2023 Competition Schematic Review

Schematic Questions:

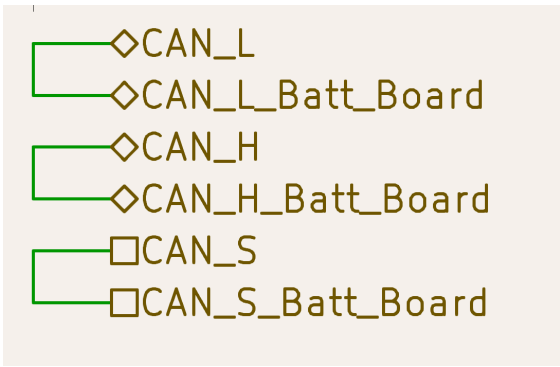
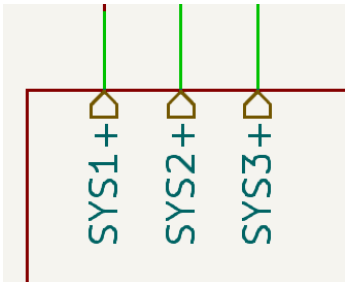
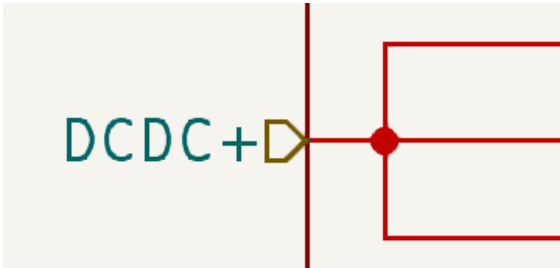
Diagram showing CAN bus connections: - CAN_L - CAN_L_Batt_Board - CAN_H - CAN_H_Batt_Board - CAN_S - CAN_S_Batt_Board	
	Which of these connections is preferred?   Diagram showing connections for SYS1+, SYS2+, and SYS3+ to a common ground. Diagram showing a DCDC+ connection to a common ground.	? Oh does it have both? If both I believe we are just doing the 3x since that's how we have it coming out of the board and it shows fusing Oh nvm, still don't know what you're asking
	The grounding for the load switch board is definitely wrong, since it doesn't show a connection to the (-) battery terminal. I assume we should remove the chassis ground at the battery, hook that up to the board instead, and then have that disconnected GND pin go to chassis

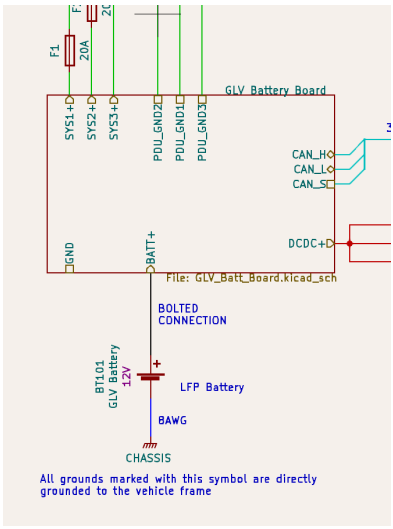
Asker	Question	Answer
Walter Stado...	Is this actually 12AWG? 	No. Load switch directly is connected. We can just put like “Direct Connection” or “Bolted” Done
Walter Stado...	Are these wire sizes accurate?	I think so? Should double check but the stuff Zack did from LV Load switch is all 16AWG I left this all as 16 for now, even though technically it probably steps up to 14 at the fuses Yes I think listing the minimum is satisfactory

GLV Battery Board File: GLV_Batt_Board.kicad_sch BT101 GLV Battery 12V BOLTED CONNECTION LFP Battery BAWG CHASSIS All grounds marked with this symbol are directly grounded to the vehicle frame	
	Not thrilled with how close the new 18 AWG wire color is to the default green, but we're kinda running out of distinguishable colors
